**ADDENDUM NO. 2**  
**PHILLIP C. SHOWELL ELEMENTARY SCHOOL**  
**CLASSROOM ADDITION**  
Selbyville, Delaware 19975

May 4, 2015

The documents for the above referenced project, Project Manual, dated March 2, 2015 and Drawings, dated March 25, 2015, as well as subsequently issued addenda, are amended as follows:

# SCHEMATIC CONSTRUCTION STORMWATER MANAGEMENT PLAN

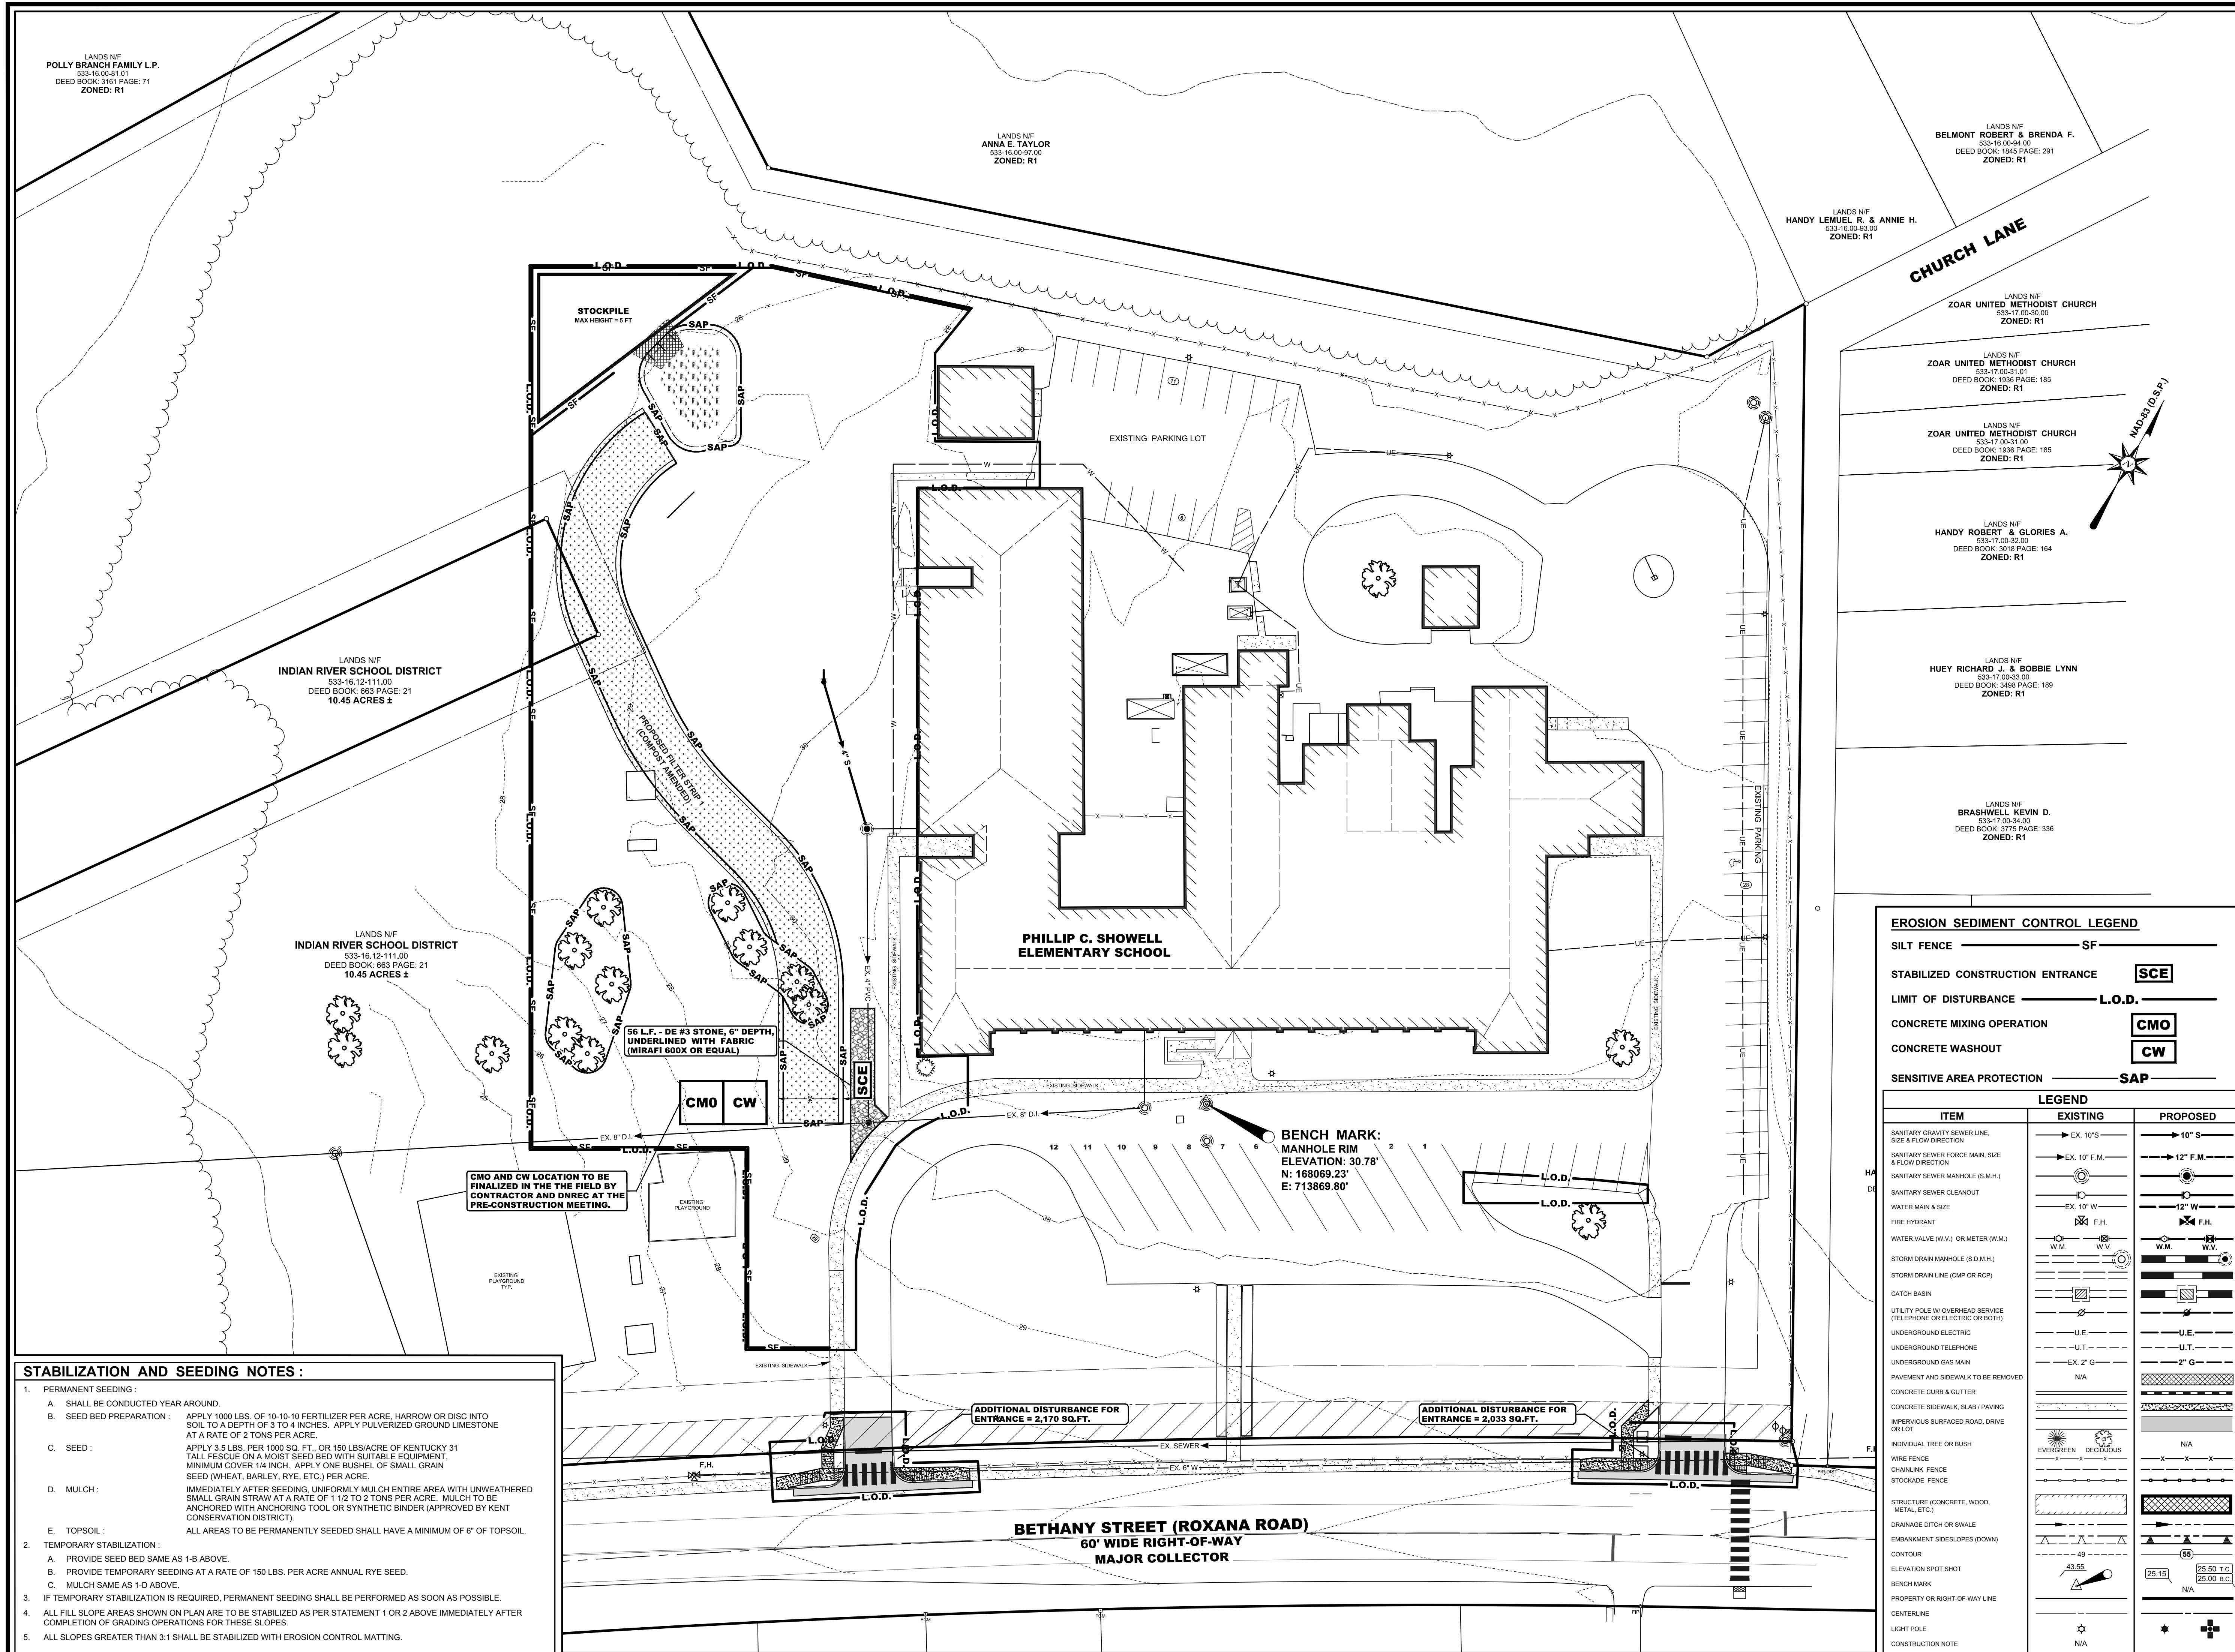
1. C-501 Schematic Construction Stormwater Management Plan
  - a. REMOVE work associated with filter strip 2.
2. C-502 Post Construction Site Stormwater Management Plan

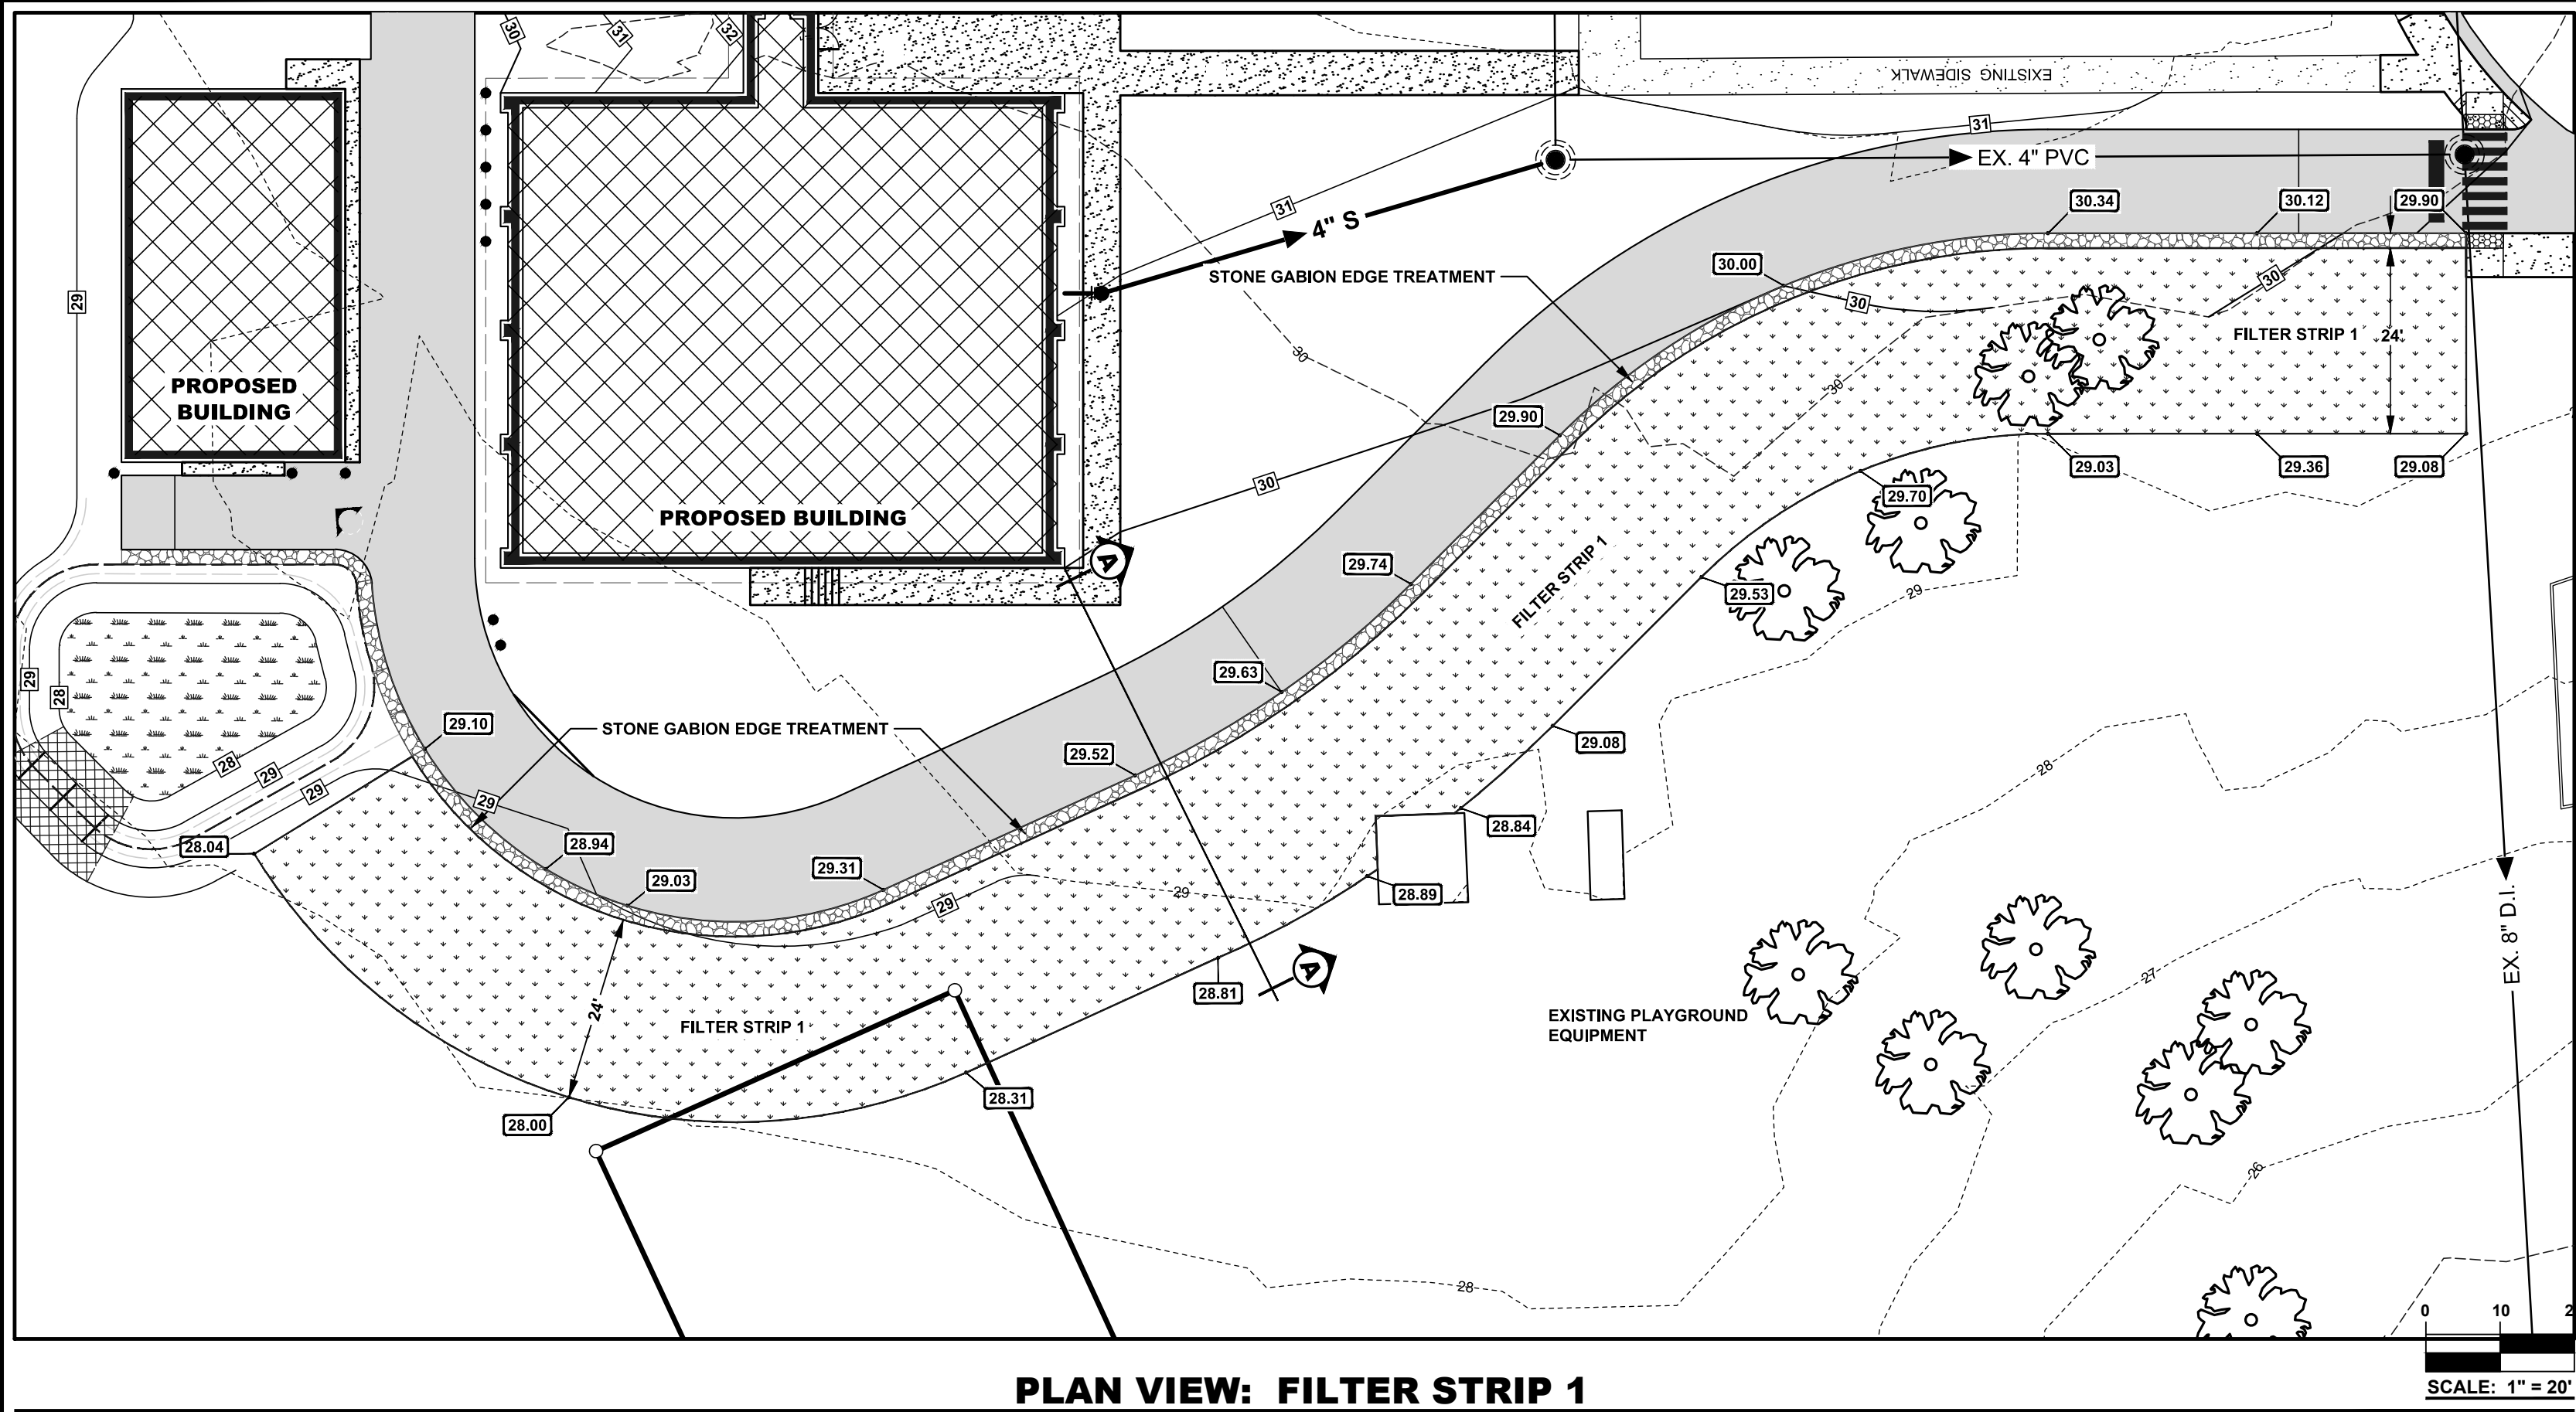
- a. ADD rain garden area.
3. C-503 Construction Site Stormwater Plan Filter Strip 1
  - a. REPLACE drawing with attached.
4. C-504 Construction Site Stormwater Plan Filter Strip 1

FOUNDATION PLAN

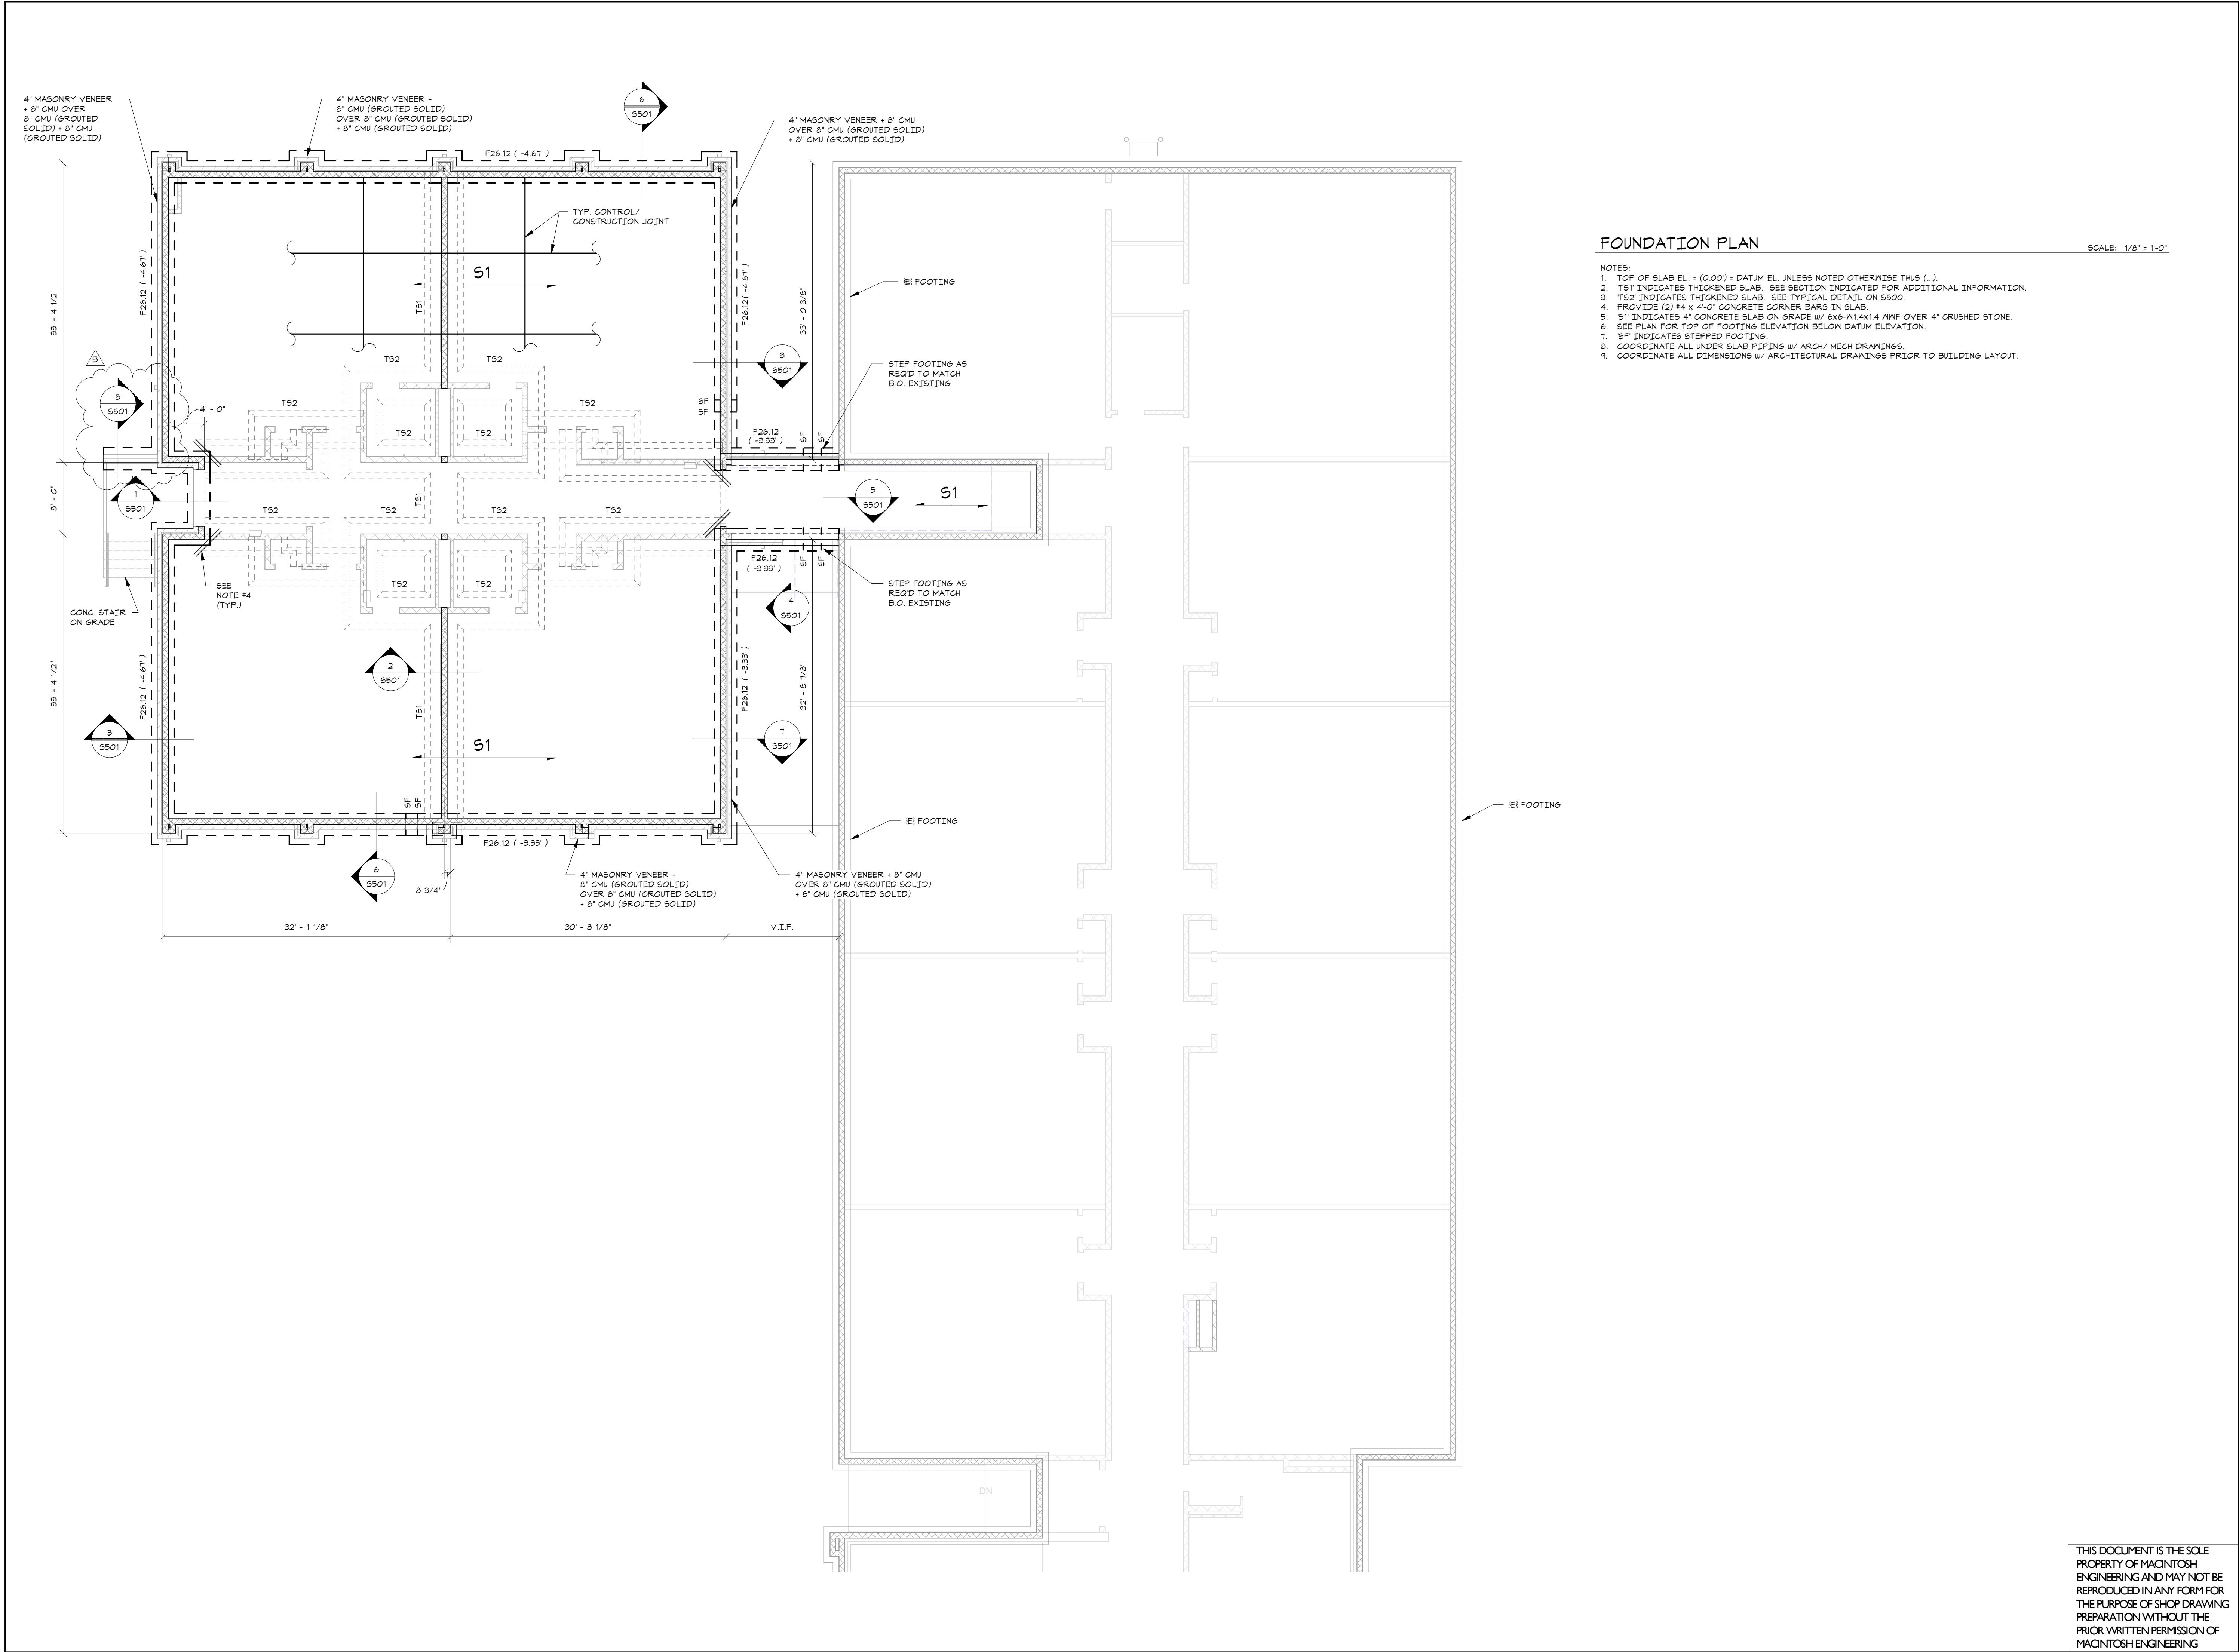
6. C-506 Sediment and Stormwater Plan Notes and Details
  - a. REVISE previous sheet C-505 to sheet C-506, per attached.
7. S101 Foundation Plan
  - a. REVISE exterior stair per attached drawing. Brick sidewall occurs on plan west and plan north sides of stair.
